**BP-2023-34420 Minor Amendment Justification Letter – Revision 2**

Please consider approving BP-2023-34420 related modifications as a Minor Amendment to the approved site plan. This project is tenant improvement of an existing office building located at 14820 Central Av SE, Albuquerque, NM. The building occupancy of this facility, Group B, remains unchanged and the minor proposed changes are being pursued to meet the owner's Laboratory - Testing and Research needs. Access to the site remains unchanged and the user's intent is to keep this building and site in their current state with two minor exceptions:

PROJECT NAME
**GENERAL ATOMICS TI
ABQ**

BUILDING ELEVATIONS

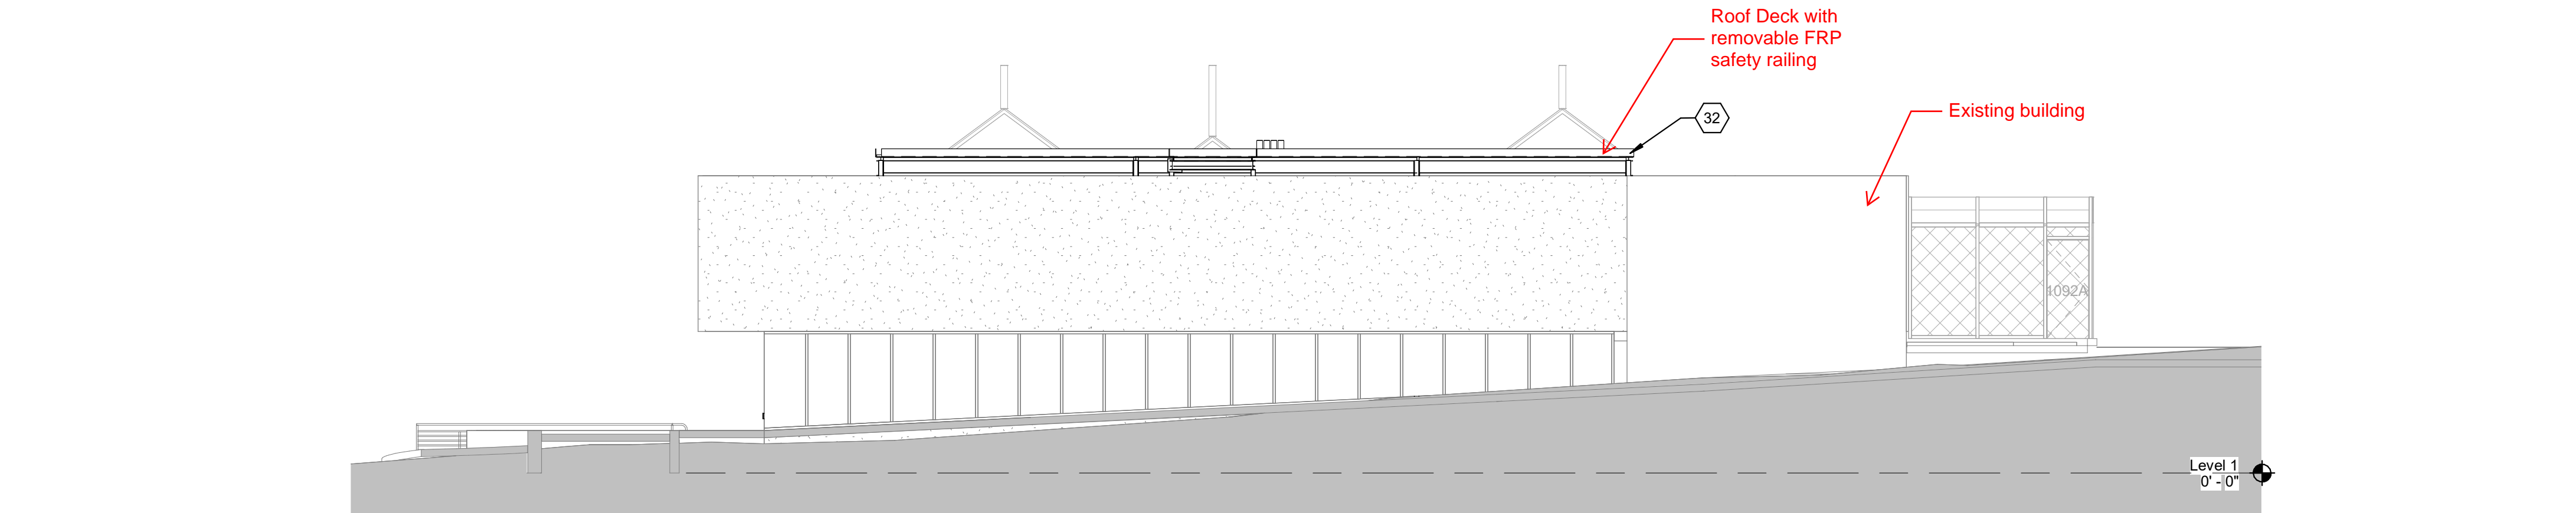
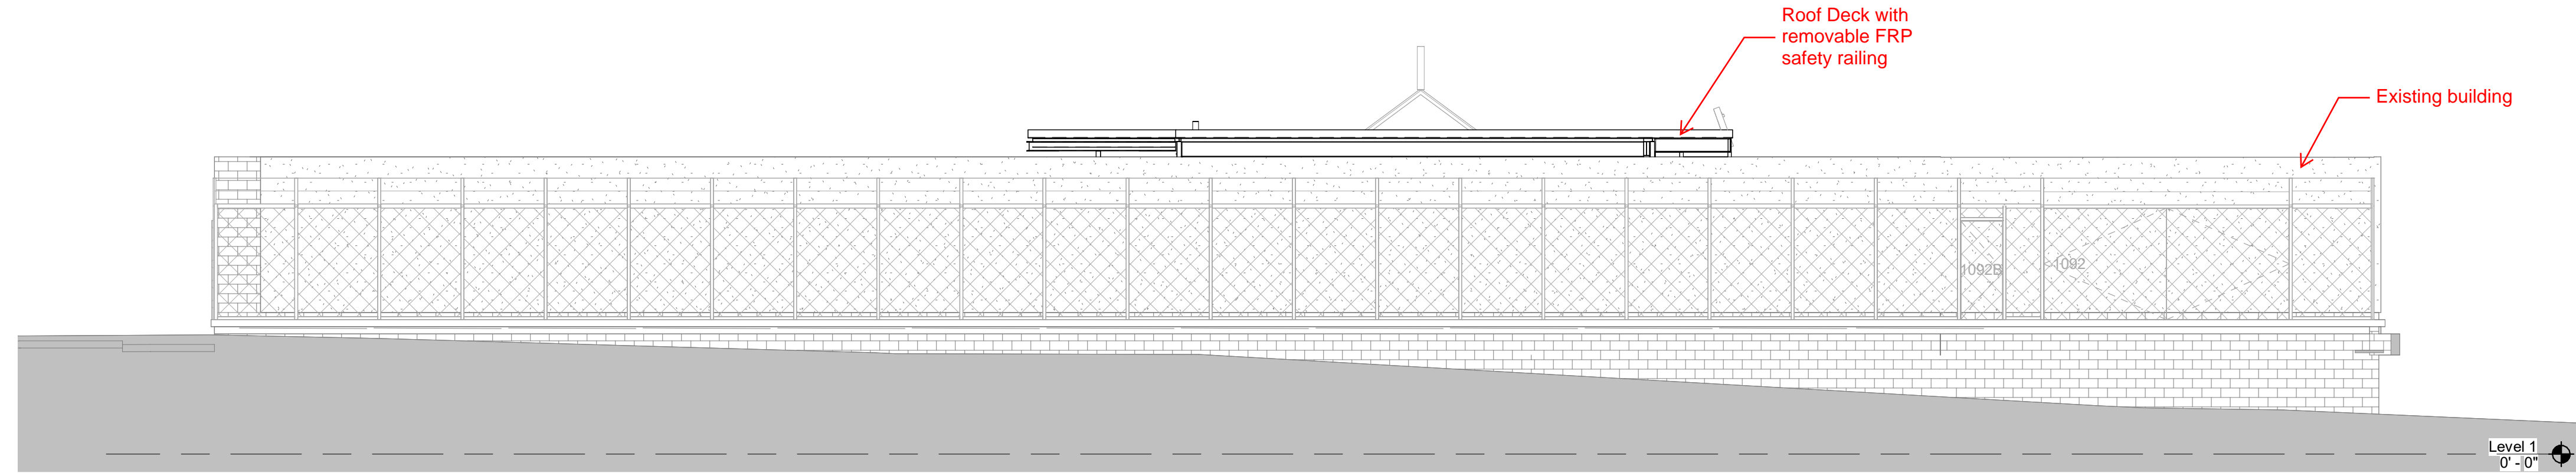
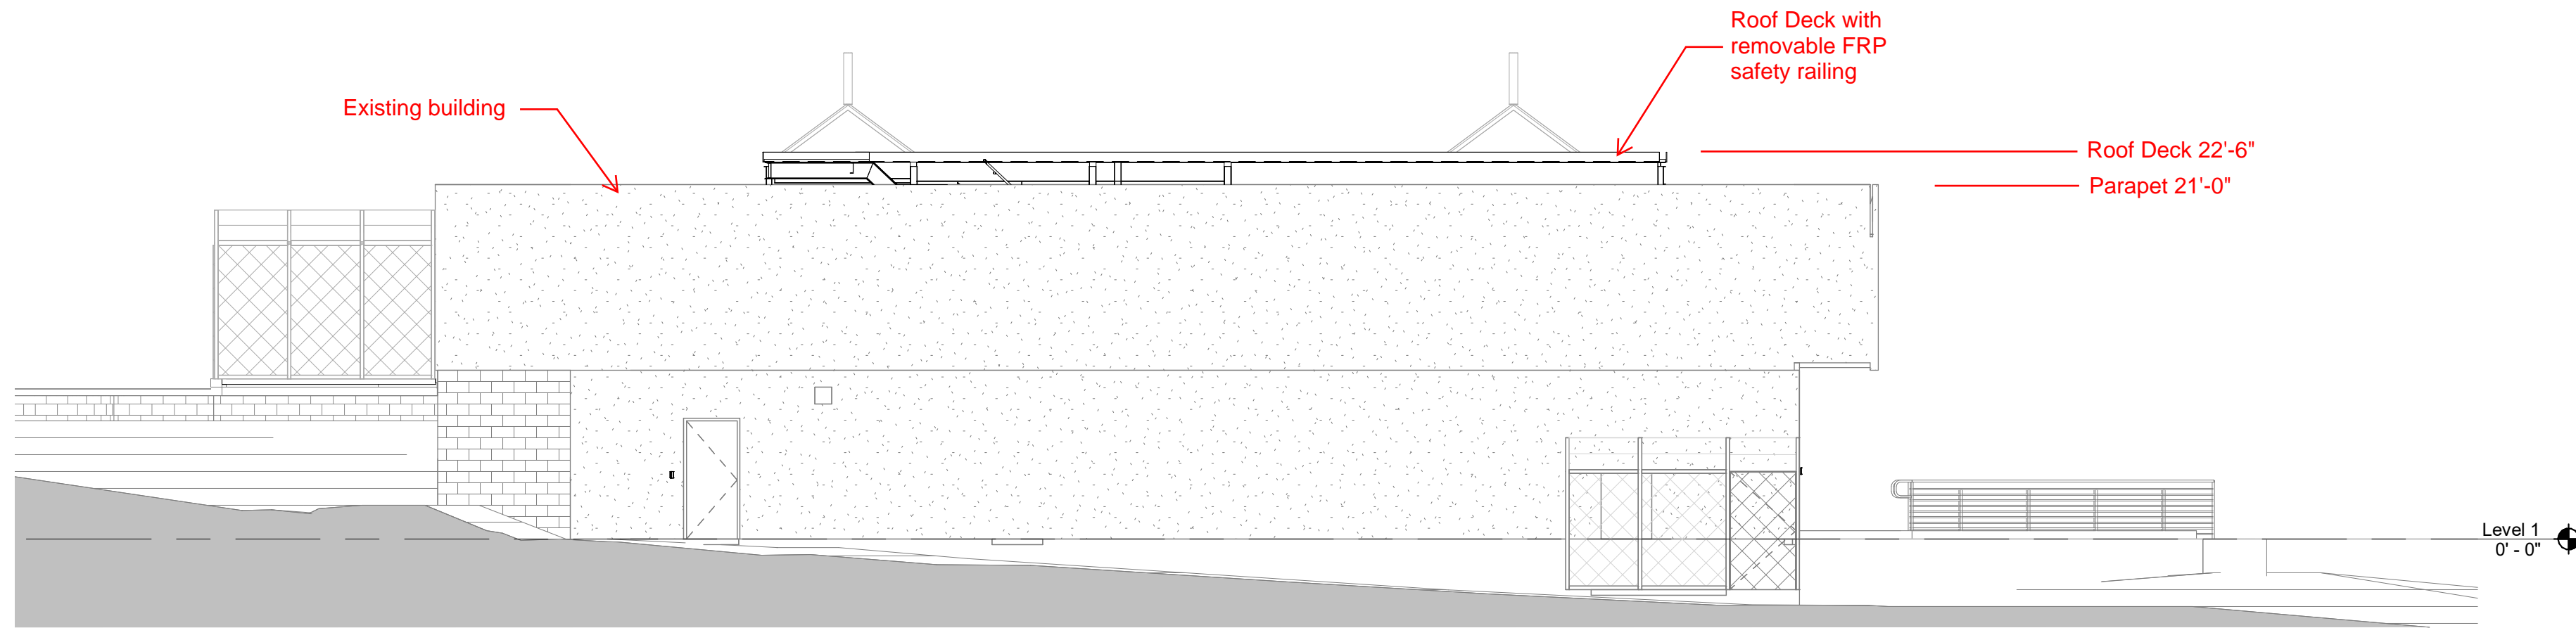
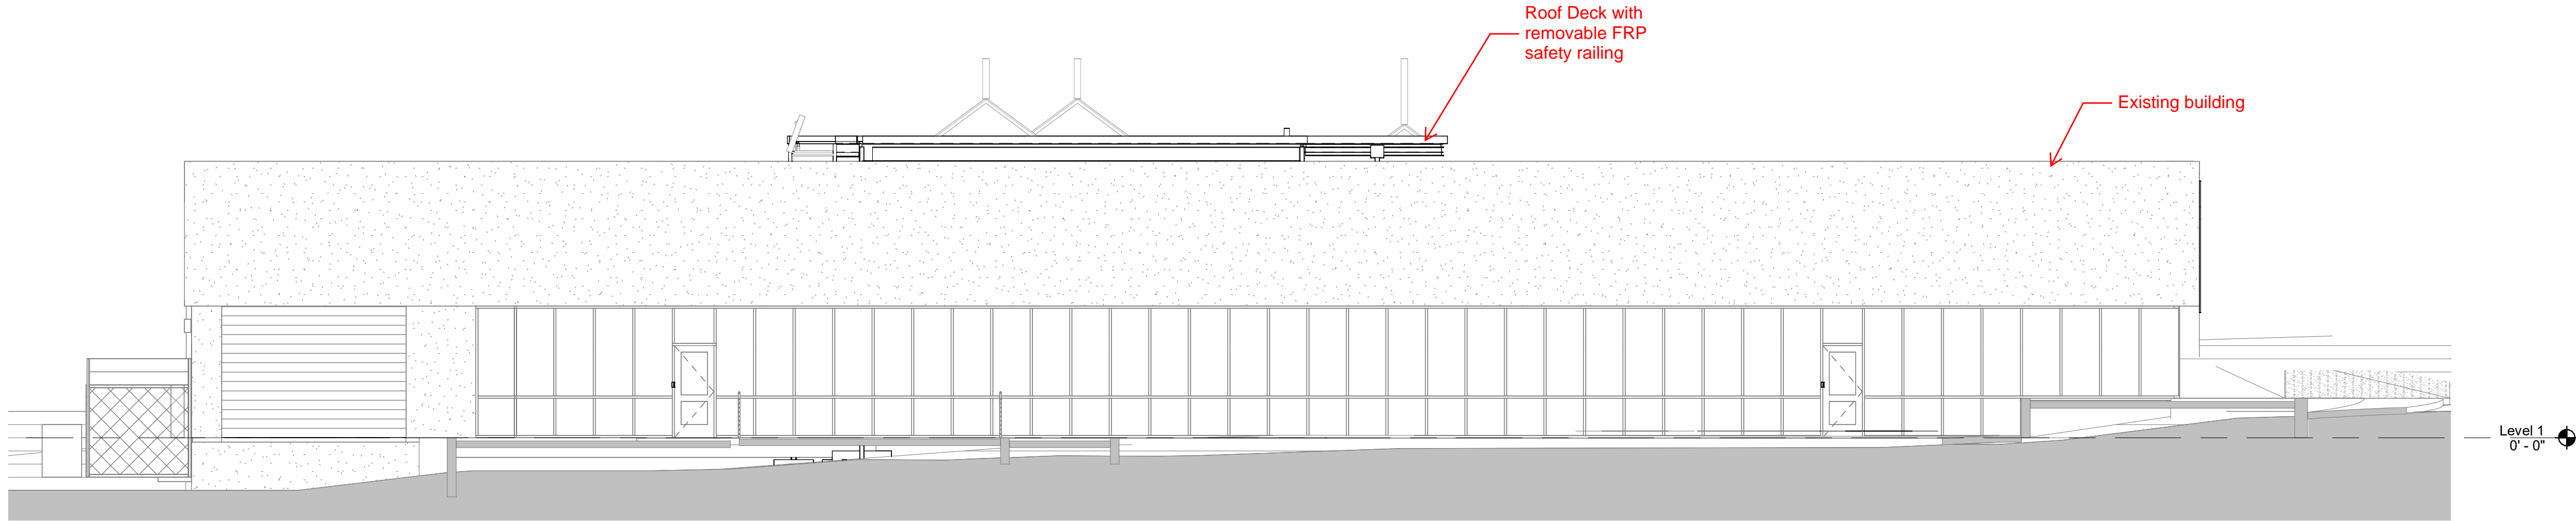
1. Rooftop Installation - Rooftop deck with removable FRP railing will be added above a portion of the existing roof. At its highest elevation this deck will be approximately 18" above the existing parapet and its purpose is to house three removable research antennas. The structural frame of this deck will be comprised of steel framing members and its finishes will match the existing roofing color (gray).
2. Addition of a Fence - Telescope trailer yard with approximately 160 linear feet of 8' R-panel security fencing will be added to the southern end of the existing parking lot.

- 32 FIELD VERIFY ELEVATION OF HIGH POINT OF STANDING SEAM ROOFING. FINISHED SURFACE OF ROOF PLATFORM TO BE 2'-2" HIGHER.
